Application ref: 2024/4872/PRE Contact: Ewan Campbell Tel: 020 7974 5458 Email: Ewan.Campbell@camden.gov.uk Date: 07/01/2024

Pre-application Medium Development Pre-application Advice Issued

Address: Land west of Ashley Court (Frognal Garages) Frognal Lane London NW3 7DX

Proposal: Follow up from 2023/4179/PRE - Demolition of existing garages and the erection of 7 x dwellinghouses (Class C3) with excavation of basement, associated amenity space, three new garage spaces, front and rear landscaping and associated works.

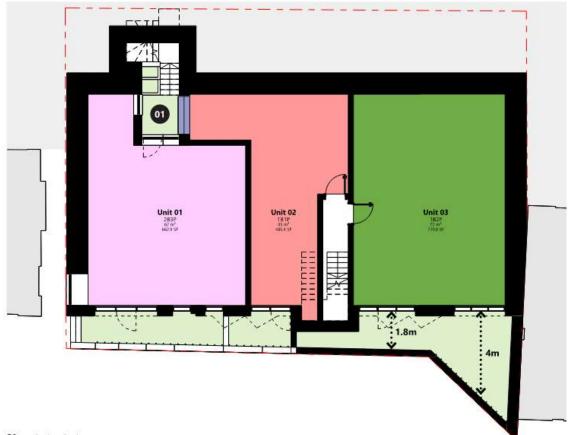
The location of the site means that any impact for properties on Frognal Lane would not be adverse. The site is 'sandwiched' in between two larger apartment blocks and therefore there would be little loss or adverse impact. To the rear, the increase in height to some degree is accepted but the loss of outlook or enclosure appears minimal due to the existing level change and the relationship of the rear windows. Overall this is acceptable.
